# LIBERTY TREE ACADEMY **CONSTRUCTION DOCUMENTS** TOWN OF PEYTON, EL PASO COUNTY PRELIMINARY DESIGN TO DENVER MAY 2018

# PPR-18-023

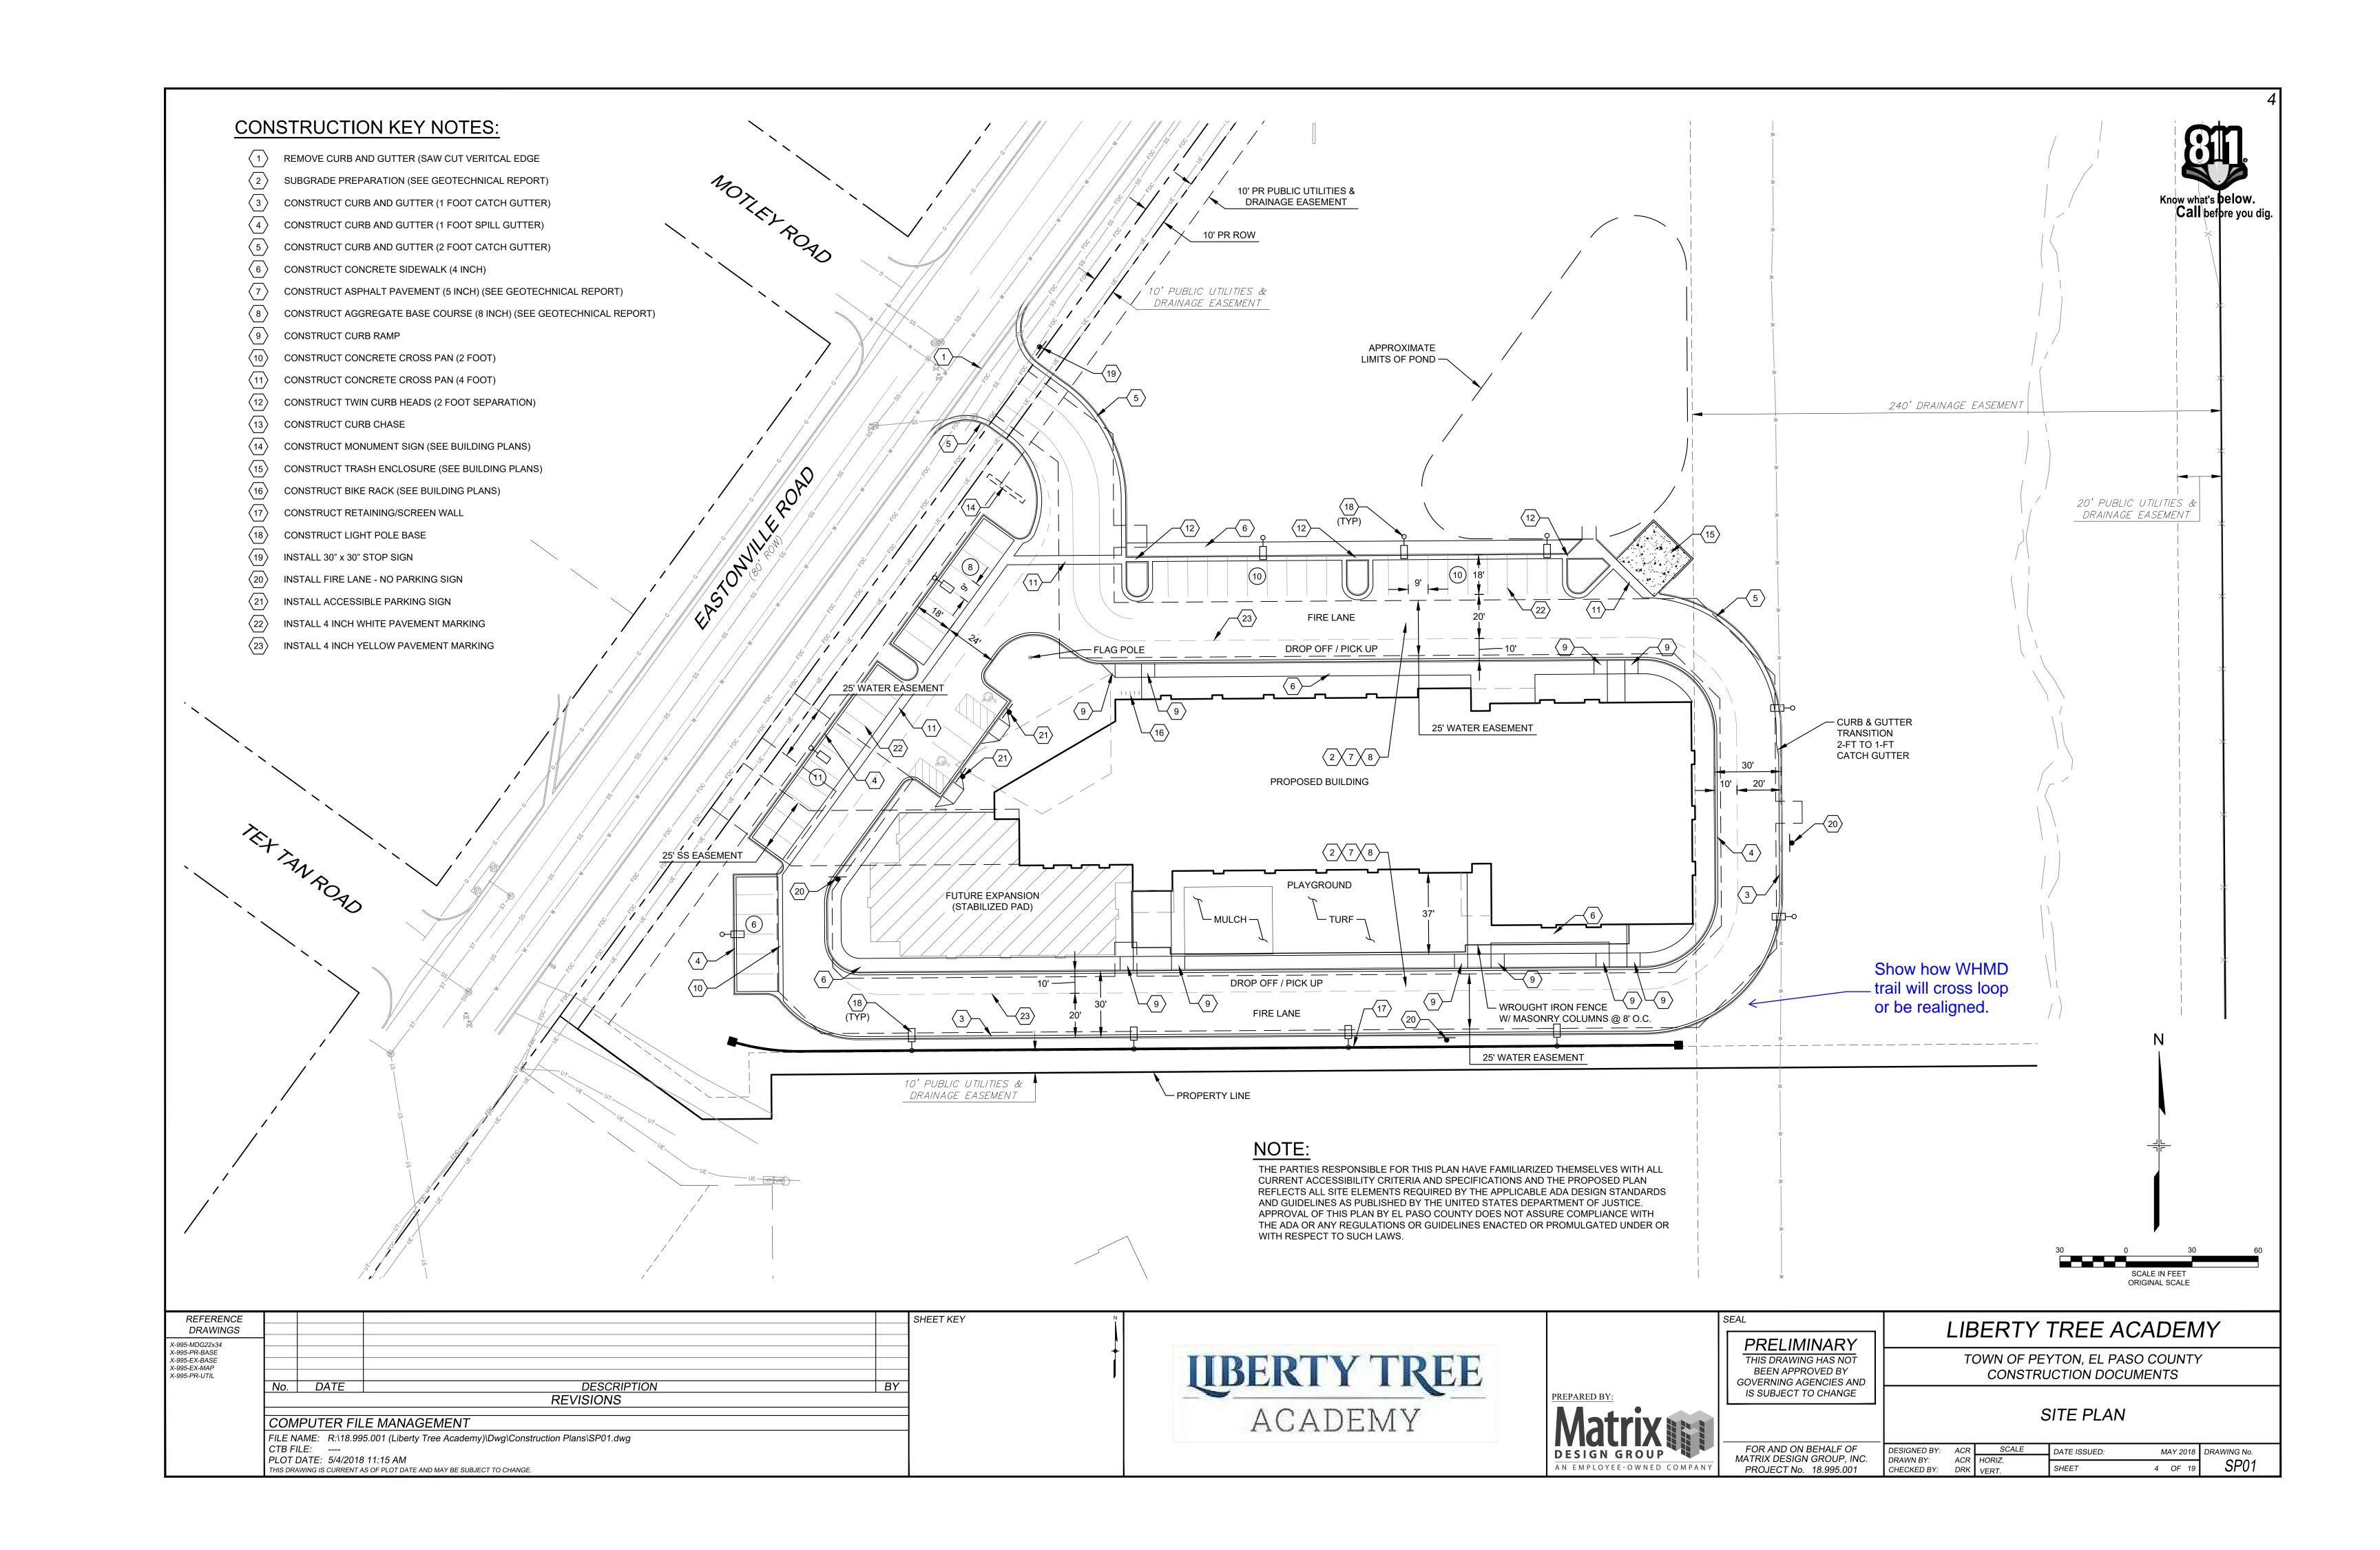
Show how WHMD trail will cross loop or be realigned.

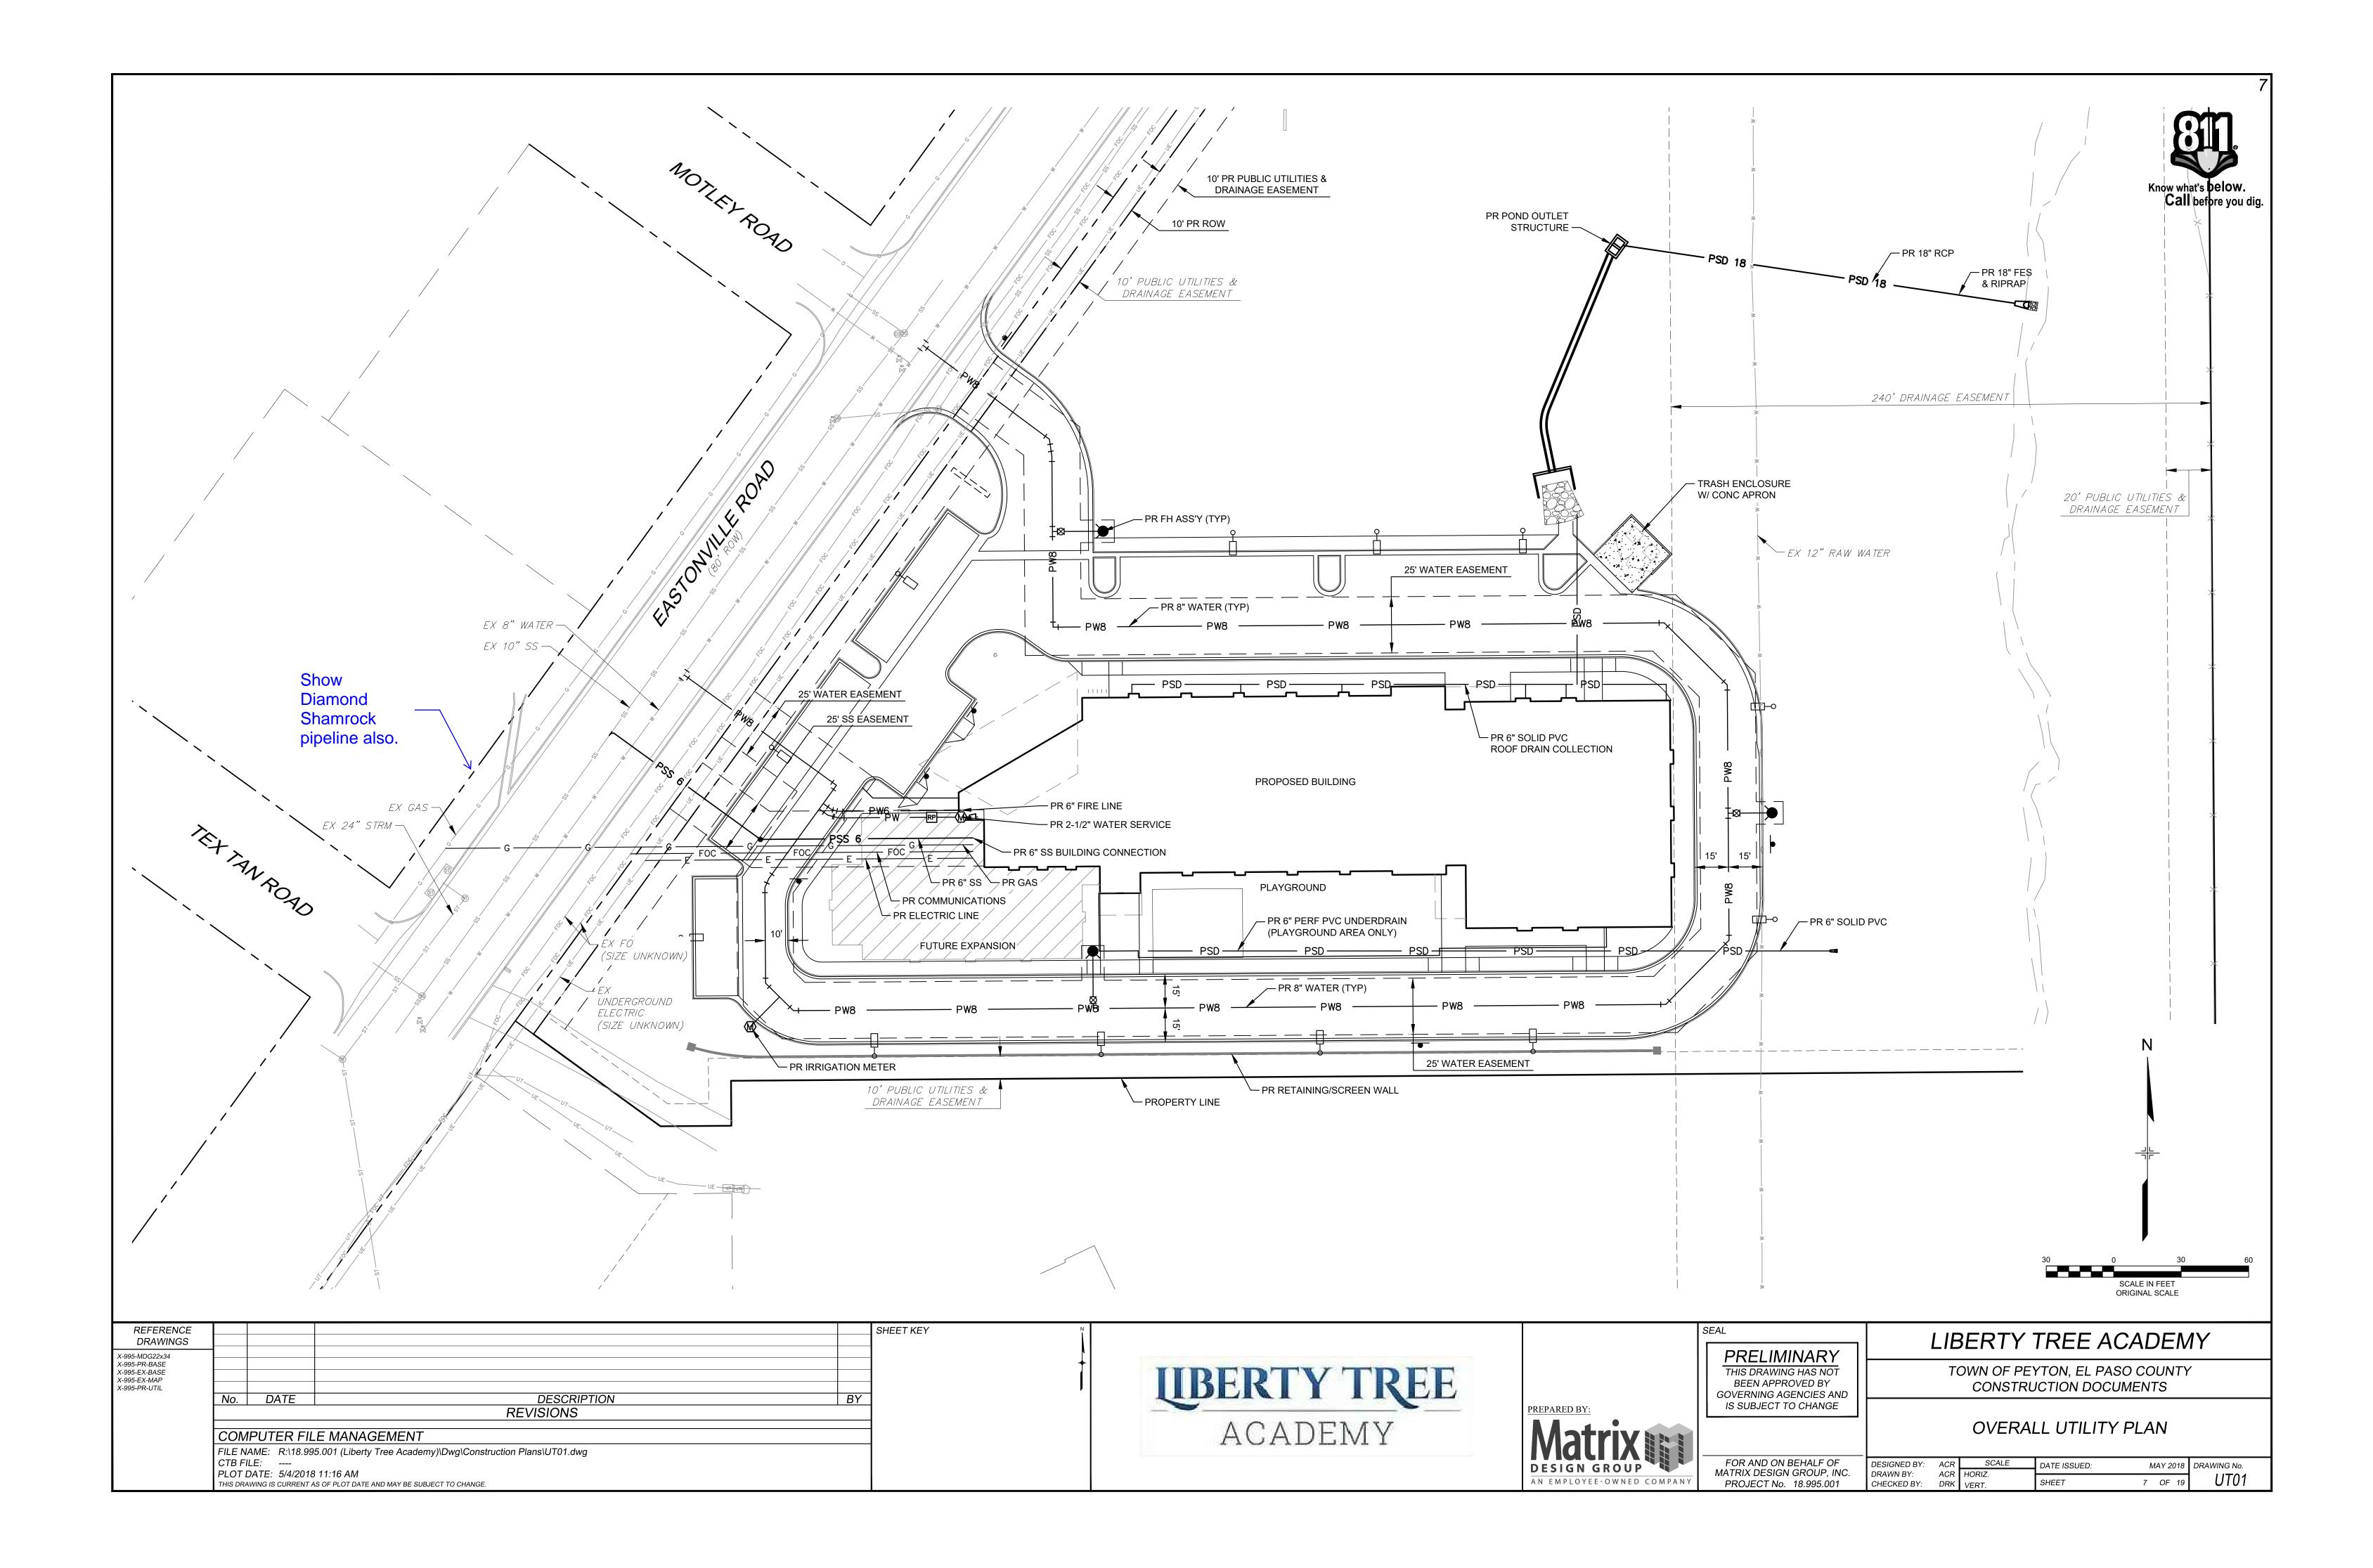
Subject: Callout Page Label: [6] GR01 GR01 Author: dsdrice Date: 6/14/2018 12:05:16 PM Color:	Show and label access trail (all applicable sheets).

Show channel cross-section locations and approximate 100-year water surface and depth (all applicable plans).

Clearly show and label existing driveway (all applicable plans). Provide documentation of correspondence with the other property owner.

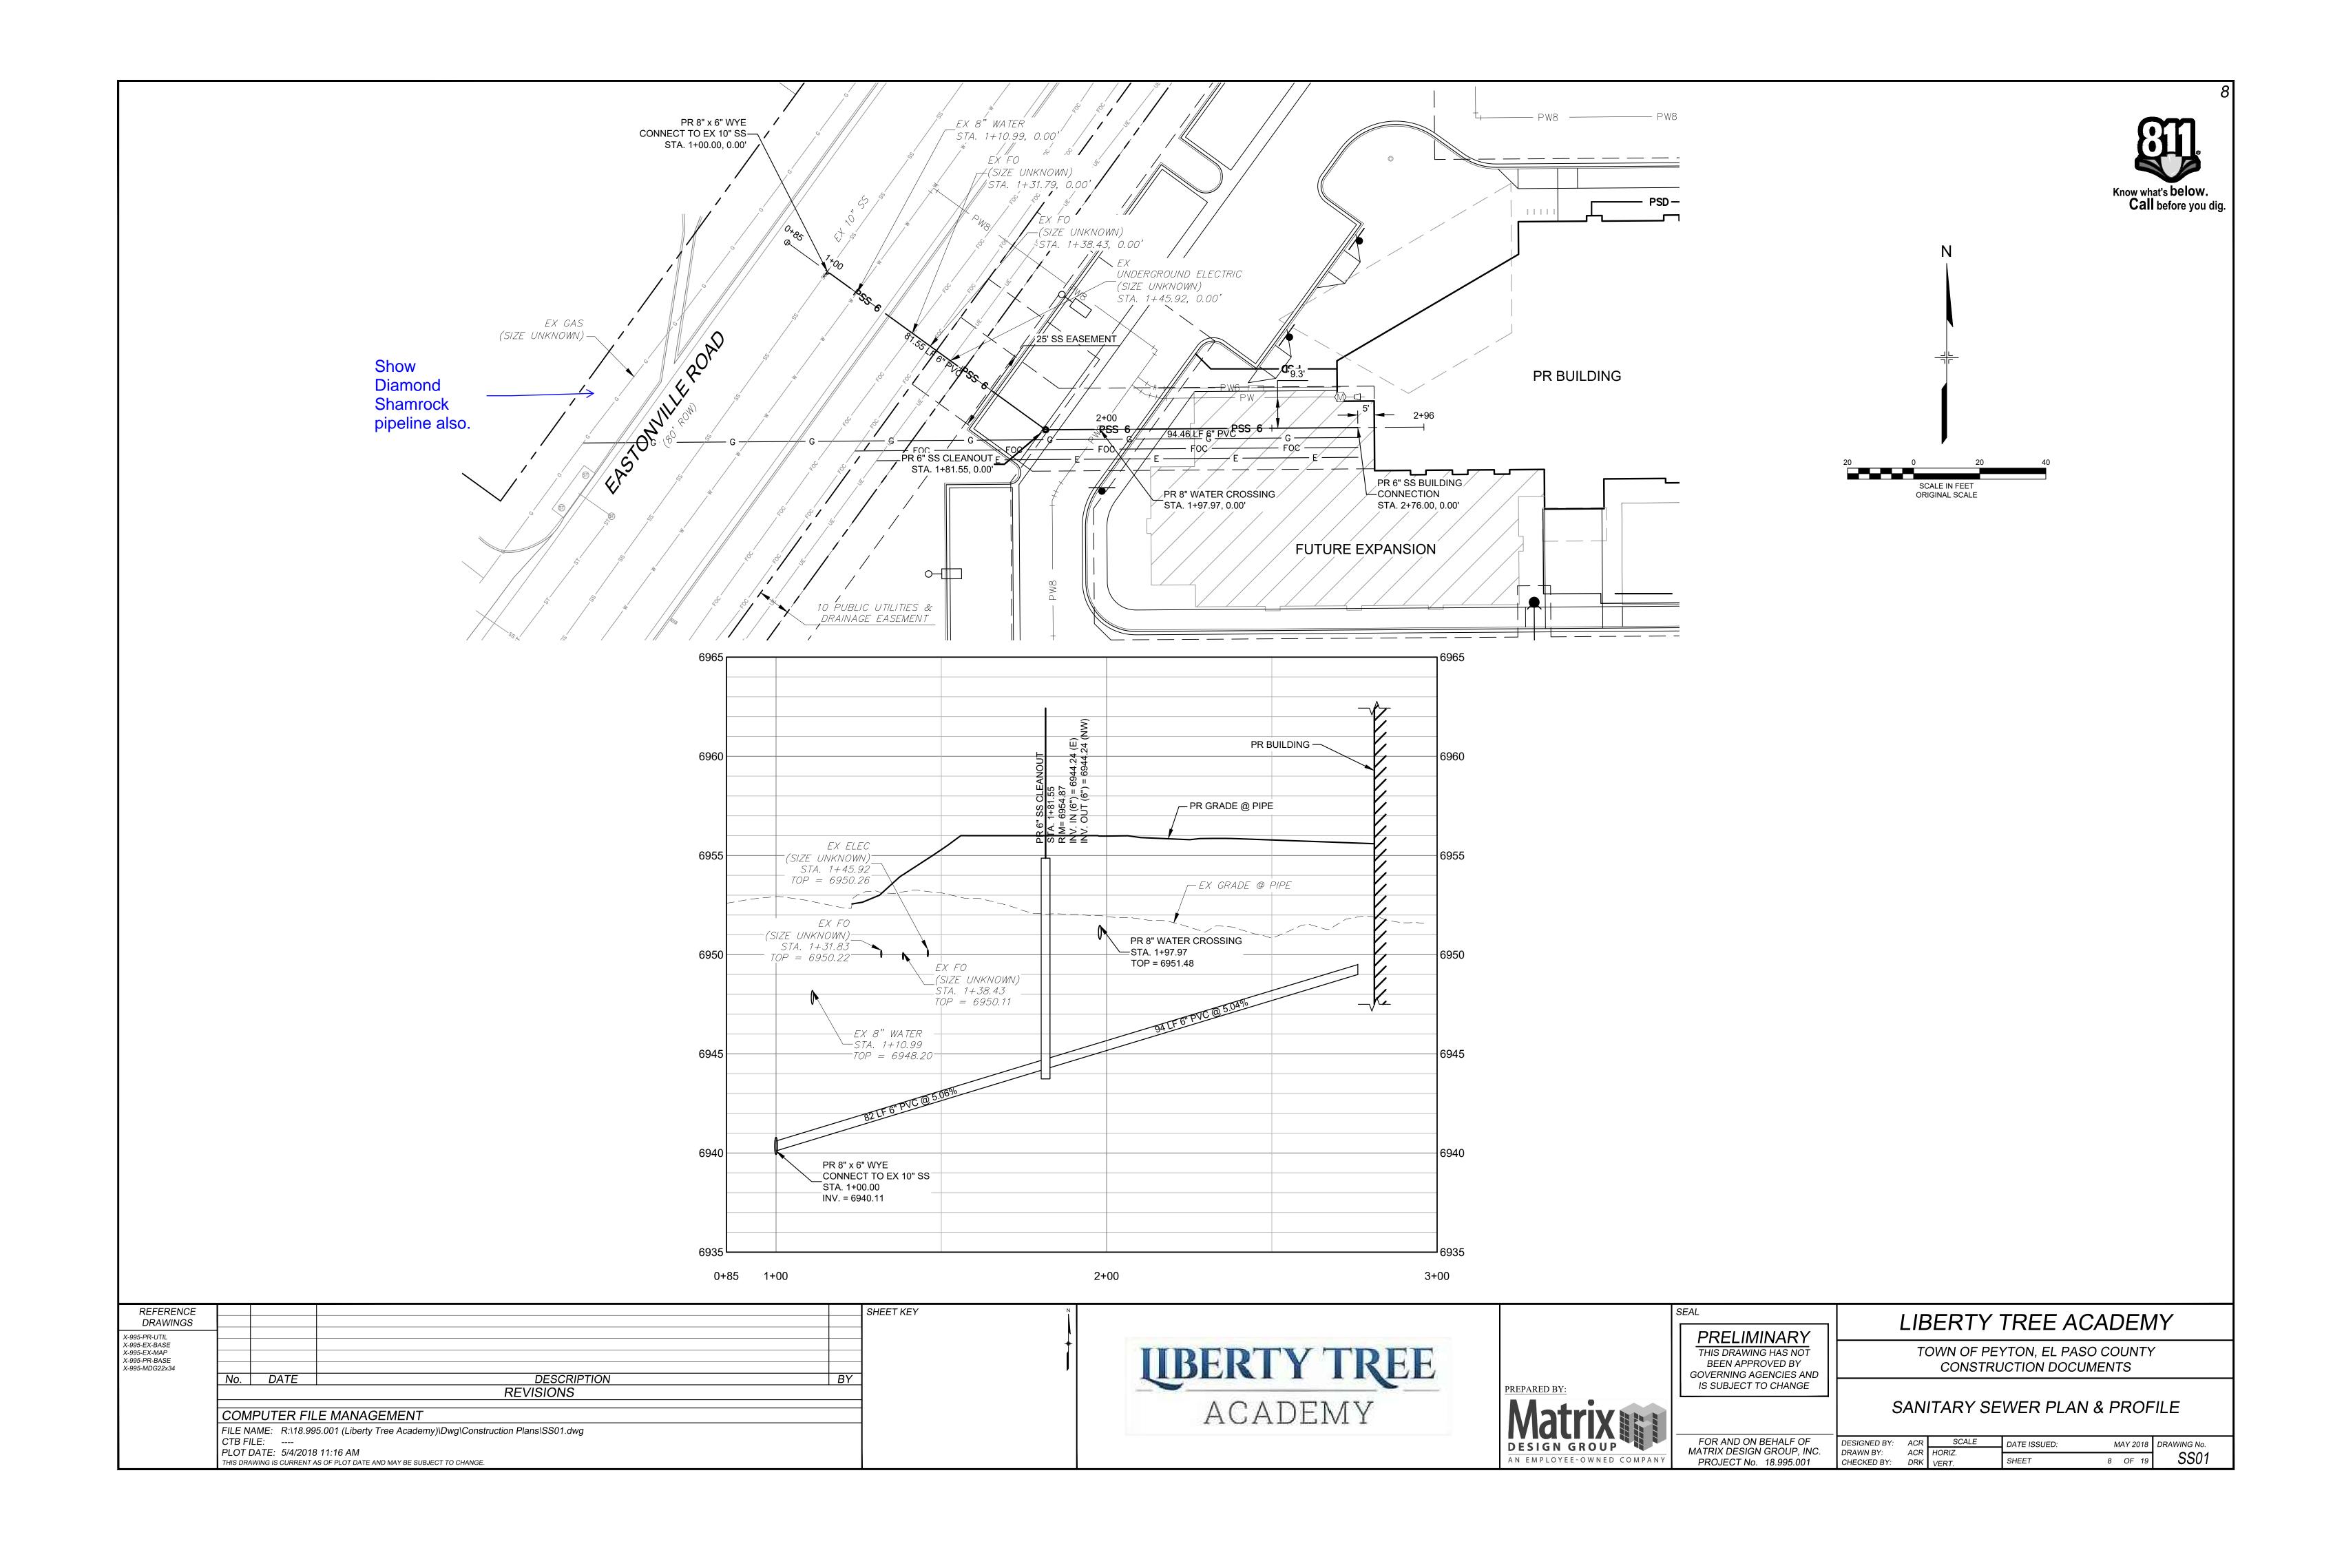
dsdrice (13)		
	Subject: Cloud+ Page Label: [1] TS01 TS01 Author: dsdrice Date: 6/14/2018 10:04:07 AM Color:	Delete/revise with final.
•	Subject: Highlight Page Label: [18] SDT01 SDT01 Author: dsdrice Date: 6/14/2018 10:07:20 AM Color:	
	Subject: Cloud+ Page Label: [13] ECDT01 ECDT01 Author: dsdrice Date: 6/14/2018 10:20:19 AM Color:	75'
75' ( and the second s	Subject: Cloud+ Page Label: [13] ECDT01 ECDT01 Author: dsdrice Date: 6/14/2018 10:21:03 AM Color:	75'
	Subject: Cloud+ Page Label: [12] EC02 EC02 Author: dsdrice Date: 6/14/2018 10:21:36 AM Color:	adjust LOC
	Subject: Cloud+ Page Label: [12] EC02 EC02 Author: dsdrice Date: 6/14/2018 10:22:28 AM Color:	Include in LOC
Brennod Brennod ppeline atio.	Subject: Callout Page Label: [8] SS01 SS01 Author: dsdrice Date: 6/14/2018 12:03:03 PM Color:	Show Diamond Shamrock pipeline also.
Show Diamond Shamrock pipeline also.	Subject: Callout Page Label: [7] UT01 UT01 Author: dsdrice Date: 6/14/2018 12:04:08 PM Color:	Show Diamond Shamrock pipeline also.
